**City Council
Work Session**

**Greenbelt Station Phase III
Site Plan – Review #2**

TO: Michael McLaughlin, City Manager *MM*
FROM: Jessica Bellah, Community Planner
VIA: Celia Craze, Director, Planning and Community Development
DATE: December 4, 2015
RE: Staff Review Greenbelt Station South Core Phase 3, DSP-13045

GREENBELT PHASE 3 CONCEPT SCALE 1"=50'

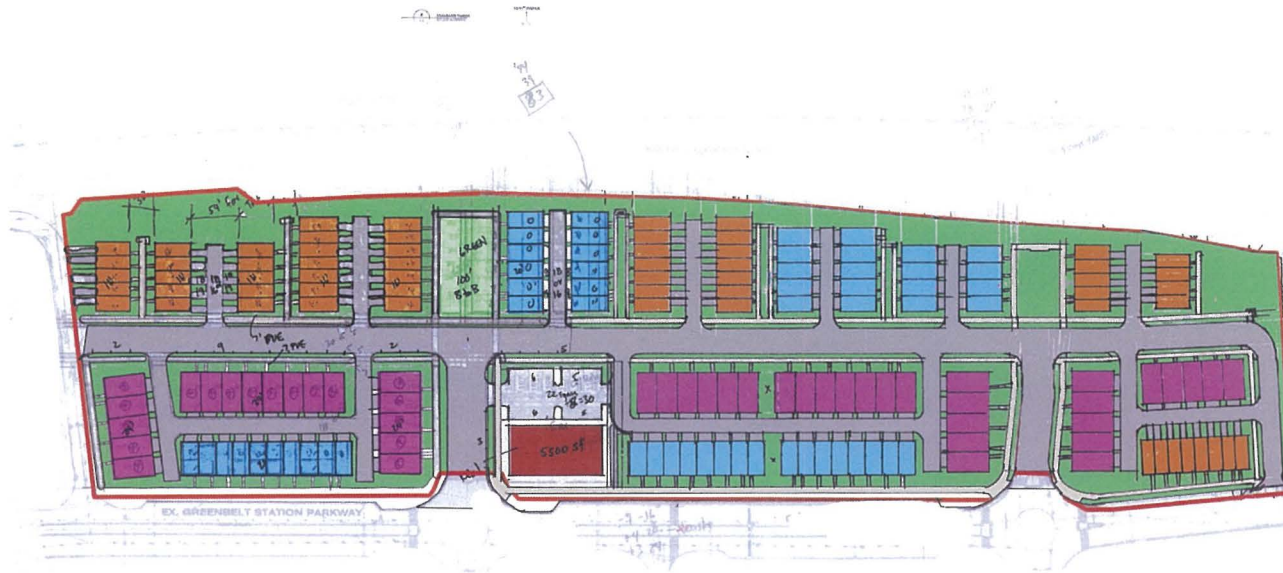
- A. The new layout provides visual relief in the massing of buildings and provides opportunities for public use of intimate green spaces. The size and placement of the pocket parks works well.

- B. The pocket parks were achieved by reducing the individual semi-private courtyard widths from an average of 50ft between buildings to approximately 30ft. For perspective, the average garden-side width between homes in GHI range between approximately 52ft and 120ft. This is not to say that smaller courtyard widths are inappropriate for a more densely scaled site plan or that 30ft courtyard widths have not been successfully applied in urban settings. Where possible, staff encourages the applicant to increase courtyard widths and provide for a central planting strip rather than the central walk through courtyards.

- There is an additional access point on Greenbelt Station Parkway from the northern end of the private interior road (Road A). To control traffic movements, staff believes this road access point should be designed as a restricted right-in/right-out point of access from Greenbelt Station Parkway.

- Distance from the first alley intersections with Road A and the intersections of Road A with South Channel Drive and Stream Bank Lane are much improved and reduce the chance of future conflict between vehicles turning at multiple points.

- The sketch plan does not provides road or alley width dimensions, however the applicant informs staff that Road A is set at 22ft travel width with 8ft dedicated for parking. Alley widths are set at 18ft.

- D. The new dedicated retail/public parkland parcel is continuous between Road A and Greenbelt Station Parkway. Staff believes the new site layout is better able to accommodate retail as part of Phase 3 development or as future infill development. Should the marketing period result in the identification of a tenant the site layout for this parcel will be refined. If the parcel is instead dedicated for use and public parkland, staff feels it is adequately sized and placed to accommodate a variety of public uses without detrimentally impacting adjacent properties.

- E. Staff previously expressed to the applicant that a lack of product integration is a detriment to the project. Between the first and second iteration of the concept sketch, staff requested that the developer provide significant integration of housing product types. The current sketch plan provides some integration of product types, but staff encourages the developers to pursue this further. Because they lack lengthy driveways, there is less room for the building groups of 20ft and 24ft housing products to “breathe”. The 16ft products

- F. The applicant informed staff that in order to achieve the new site layout and provide a landscaped buffer on either side of Road A, the public utility easement (PUE) in front of homes on Greenbelt Station Parkway was reduced from 10ft to 7ft and yards for these homes were also reduced. Staff requests that the applicant verify with utility companies that a 7ft PUE is sufficient. Additionally, staff will review any future landscape plan to ensure that tree plantings can be accommodated in front of homes either within the right-of-way or in front yards.

- 1) The new northern access road connecting to Greenbelt Station Parkway shall be designed as a right-in/right out connection.
- 2) Homes with frontage on Greenbelt Station Parkway shall maintain an acceptable distance between the building footprint and the nearest public walkway. This distance shall consist of, at minimum, 12ft contiguous pervious landscaped area such as grass and/or planting beds. It may include areas dedicated as PUEs. Staff requests that the applicant provide sufficient front yard area to accommodate tree planting in front yards.

- 3) Staff recommends the applicant carefully distribute and further integrate 16ft, 20ft and 24ft products throughout the development as the design is refined.

- 4) Staff recommends that the location and size of pocket parks shown in the concept plans be maintained as the design is refined. Staff encourages the applicant to thoughtfully apply landscaping in a manner that shields the sound barrier wall and maintains usable open space in the park centers.

- 5) Staff recommends that the width of courtyards between buildings be increased from 30ft to ~40ft. This should NOT be achieved by reducing the size of new public pocket parks or greatly altering their placement. Staff believes the developer could achieve greater courtyard green area through the integration of product type by utilizing their varying building and driveway depths to achieve more courtyard green space.

- 6) Staff recommends that courtyard walking paths incorporate the u-shaped walks rather than a single central walk. This design would place sidewalks closer to the houses and maintain a central green space as discussed and recommended by the Advisory Planning Board.
